Reference: 21.057r06v01

**Re: 24-26 Gallipoli Road, Long Jetty (DA/1260/2021)**  
**RFI Supporting Statement – Section 4.55**

Drawing Title  
Swept Path Analysis  
11.0m Council's Waste Collection Vehicle  
Ground Floor

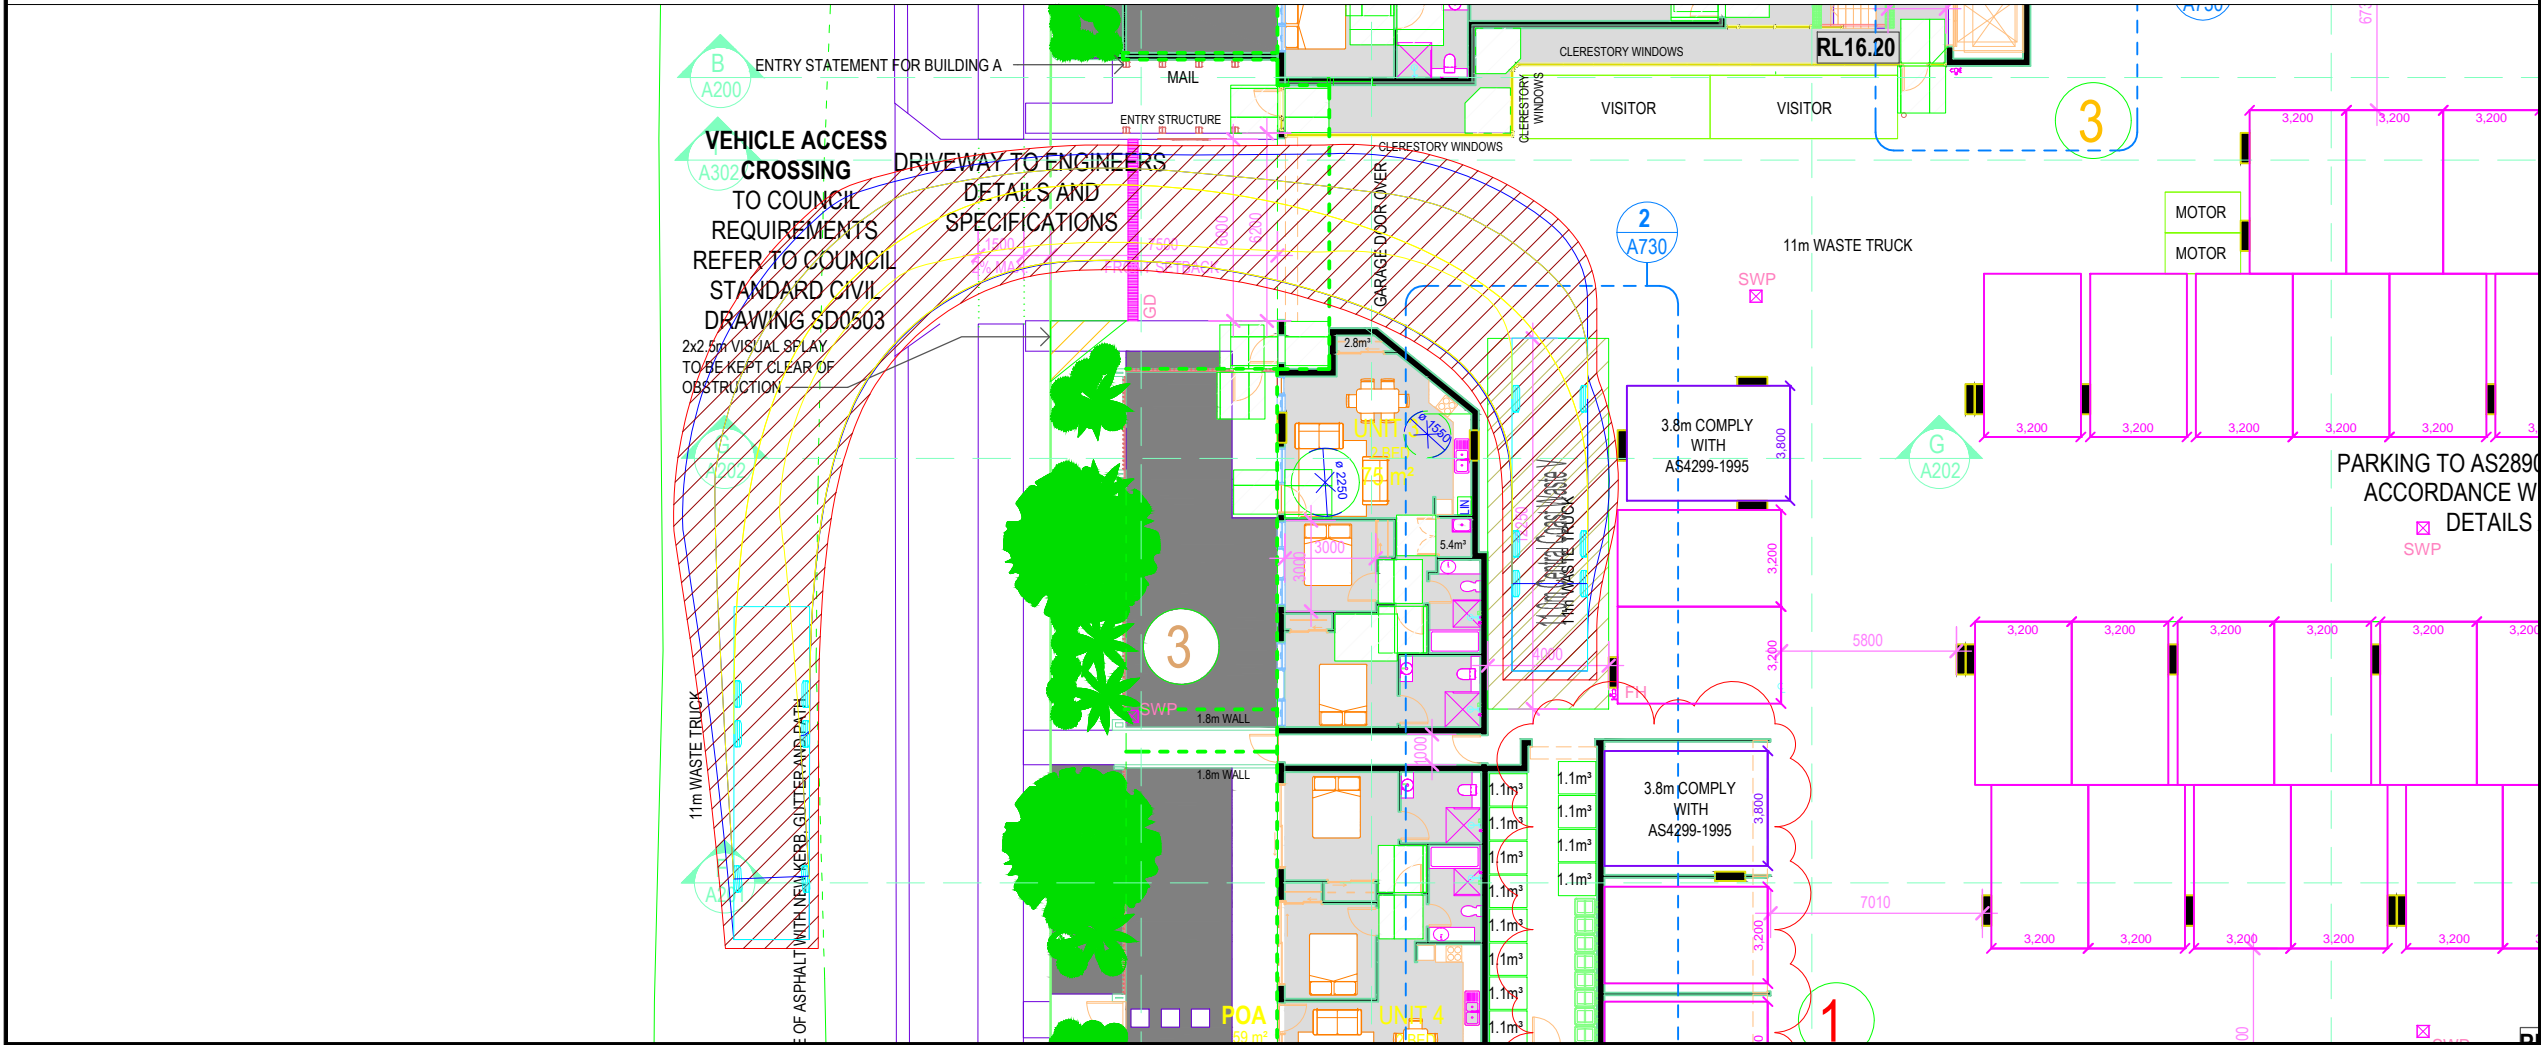
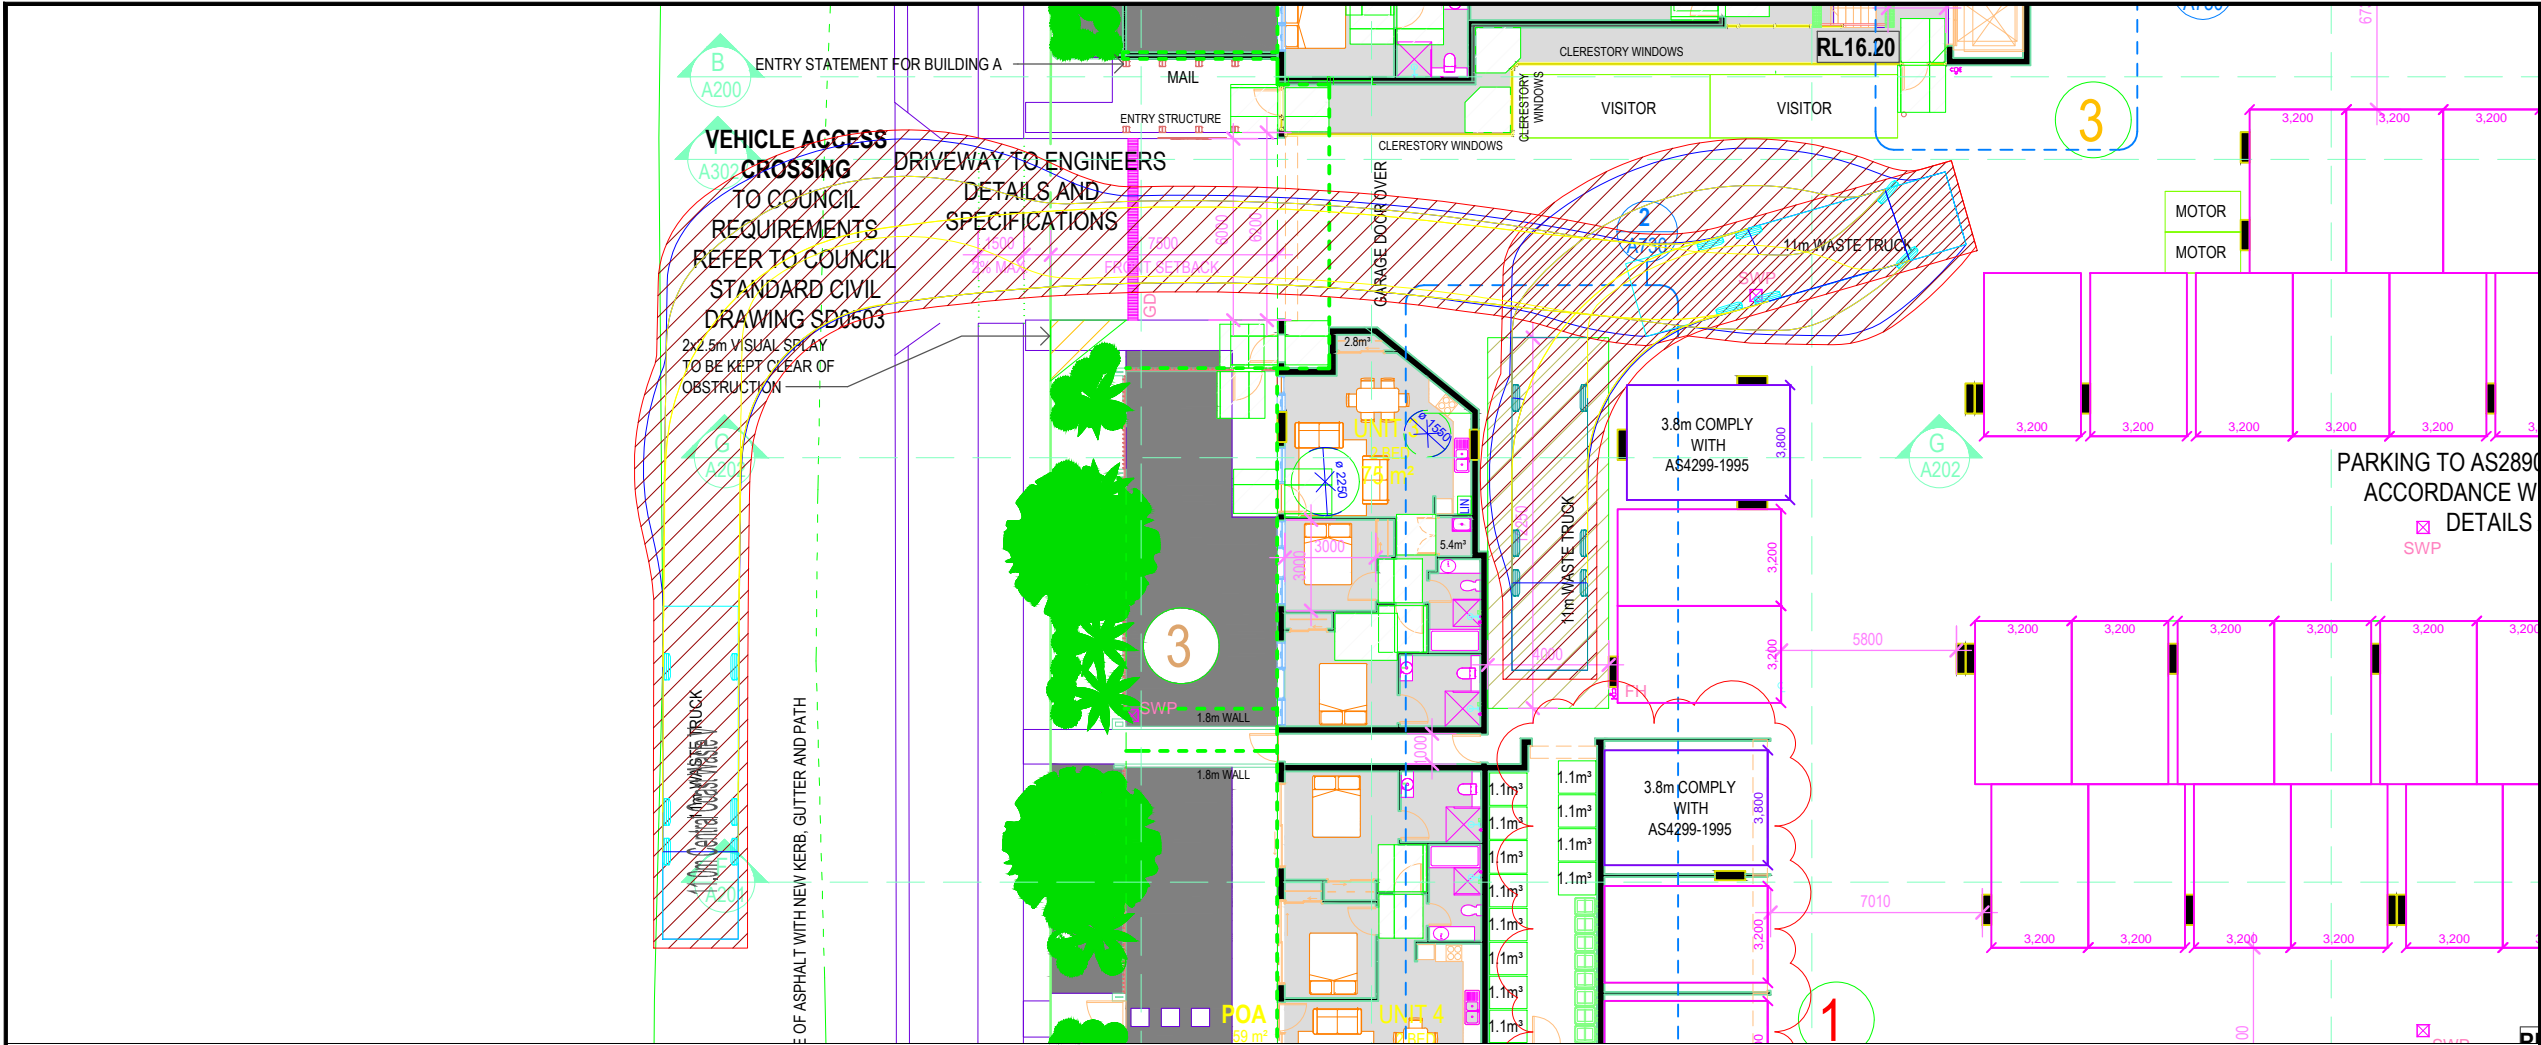
- Waste storage facilities and areas for waste vehicle servicing appear to have been reduced in the modification.

Swept path analysis has been conducted for the waste collection vehicle into and out of the loading bay showing satisfactory operation in accordance with AS 2890.2 (2018). Reference should be made to the swept path analysis provided in **Attachment 1**.
